**AGENDA
TOWN OF PITTSFORD
PLANNING BOARD
MARCH 23, 2026**

Greater Living Architecture P.C., Root 31 Relocation
Special Use Permit

TOWN OF PITTSFORD
DEVELOPMENT REVIEW COMMITTEE – Planning Comments
For Planning Board Meeting 3/23/26

SUBJECT: Root 31 Café
 Special Use Permit
 3349 Monroe Avenue (Pittsford Plaza)
 Tax Parcel #150.12-1-18

SHEET TITLE: LIFE SAFETY PLAN AND DETAILS
 SHEET NUMBER: G1.0

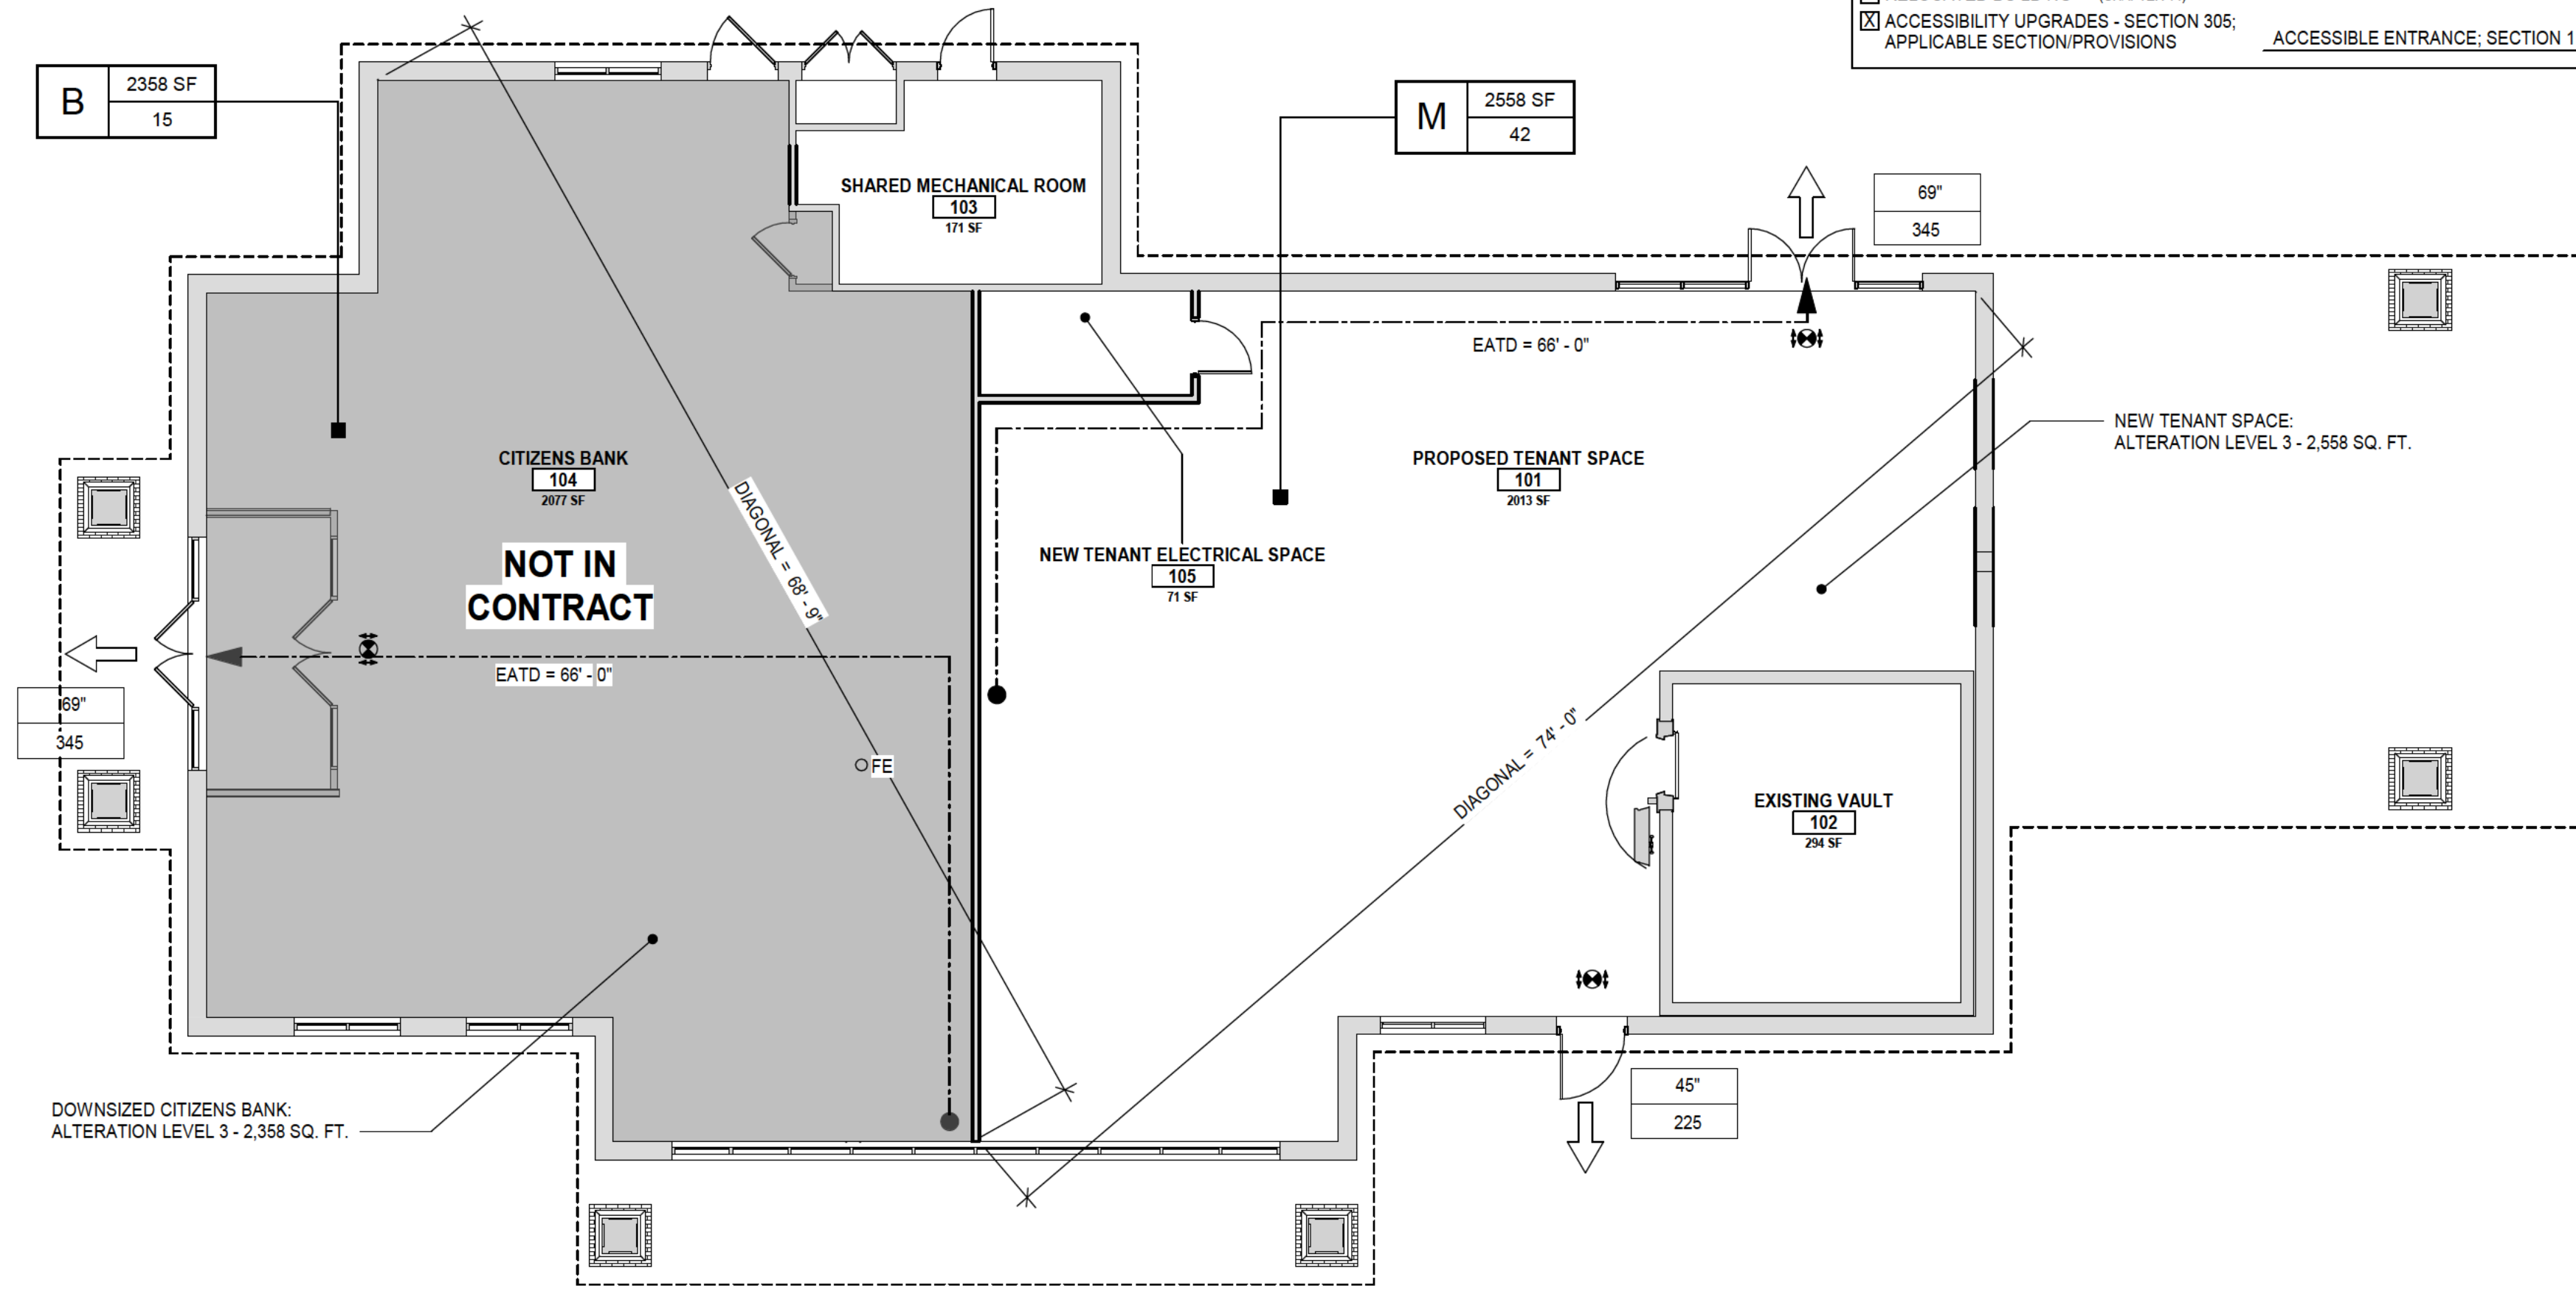
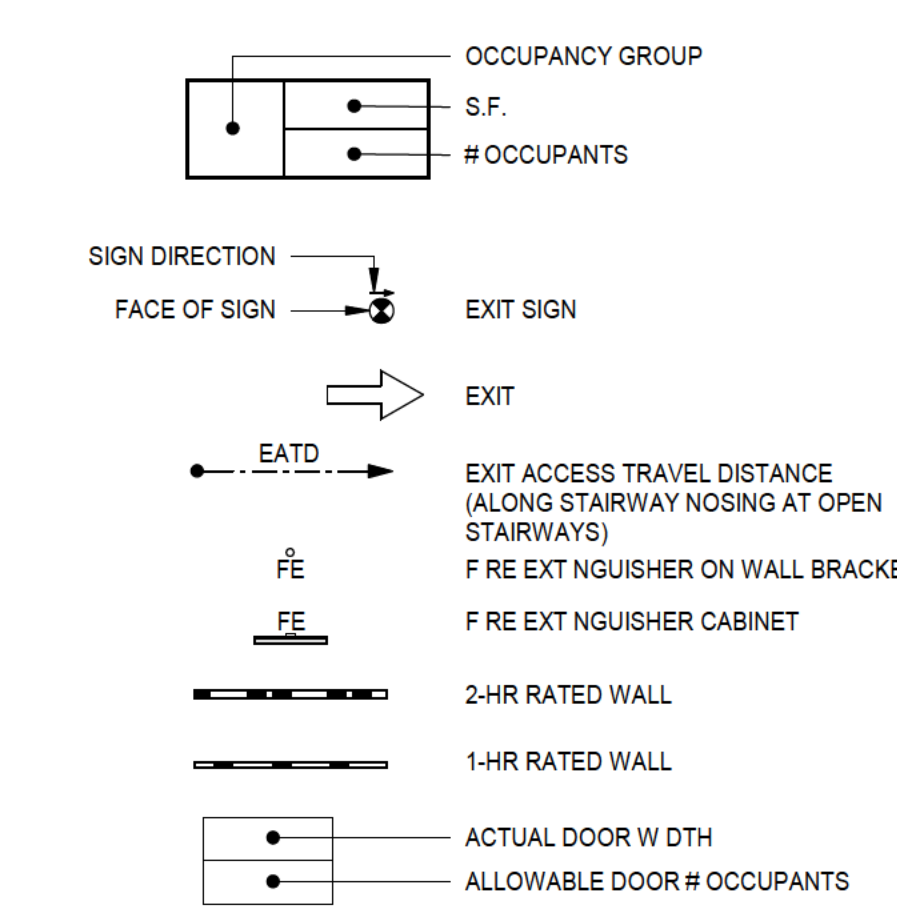
The submitted life safety documentation previously identified Group B/M (bank/retail). The new layout clearly reflects restaurant use (Group A-3) with commercial kitchen, bar, indoor and outdoor dining

- Confirm final occupancy classification as Group A-3 Assembly (restaurant).
- Provide updated occupant load calculations per 2020 BCNYS Chapter 10.
- Confirm mixed occupancy separation compliance between the new project and the bank.

Previous code summary indicated sprinklers were not required under prior occupancy assumptions

- Confirm whether the building is or will be sprinklered.
- If occupant load ≥ 100 (Assembly), sprinkler system may be required per BCNYS §903.2.1.3.
- If not sprinklered, provide documentation demonstrating sprinkler threshold not triggered.
- Confirm FDC location and access if applicable.

FIRST FLOOR PLAN

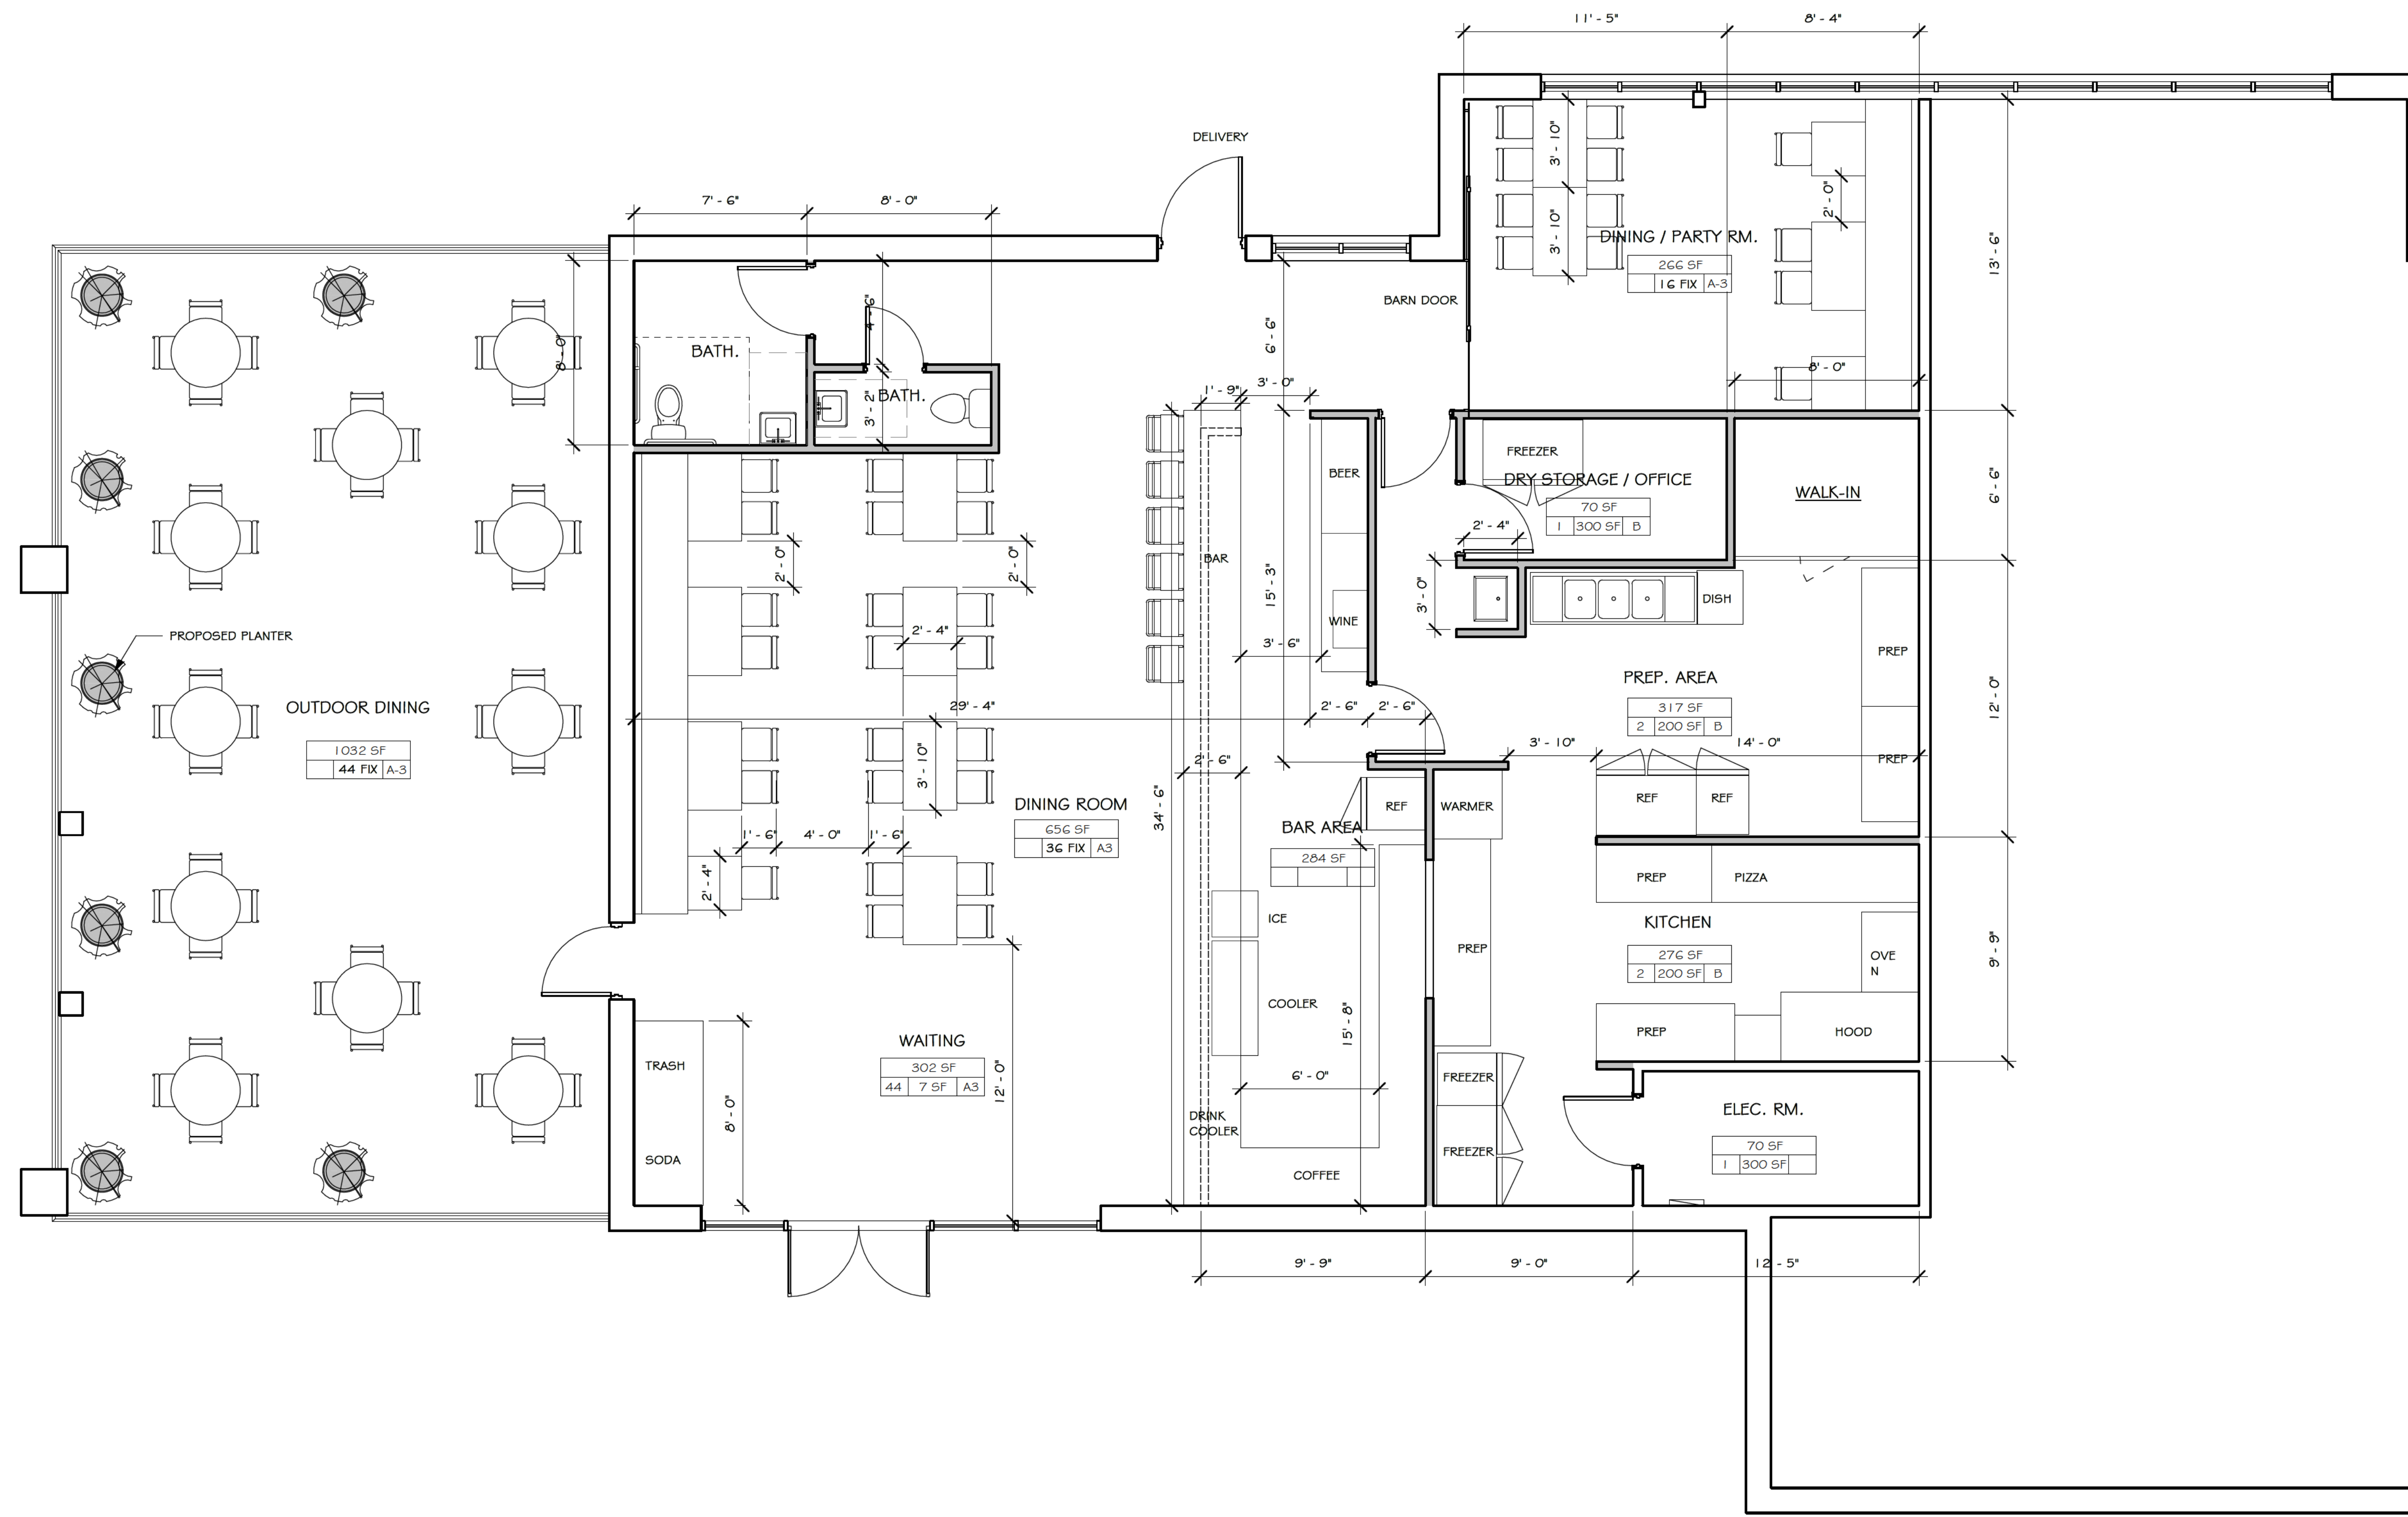
23. The concept floor plan shows a new door on the front of the building and under the former drive-thru as well as the conversion of the former drive-thru to an outdoor dining space. Architectural plans should address any modifications to the exterior of the building as well as interior modifications. Changes to the exterior elevations of the building will need to be approved by DRB. (TE)

9. Vestibule / Energy Code Consideration

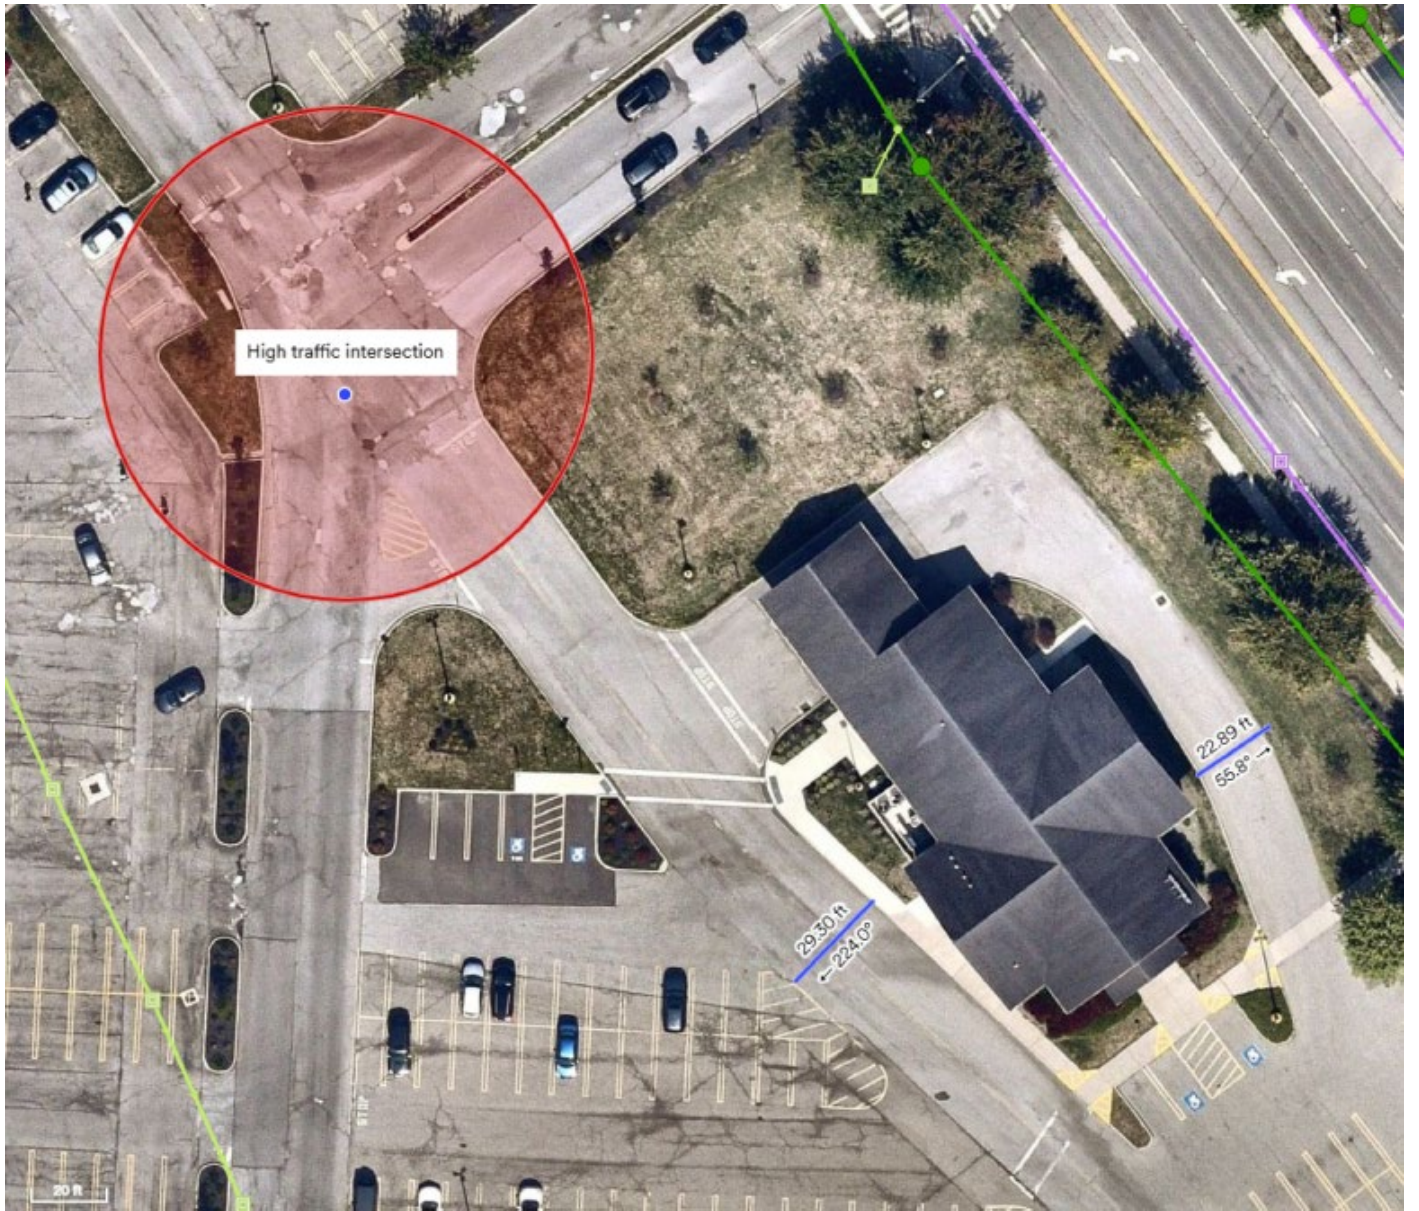
Given primary entrance directly faces parking/traffic area:

- Confirm whether vestibule required per Energy Code.
- Consider air infiltration impacts given high-traffic restaurant use.
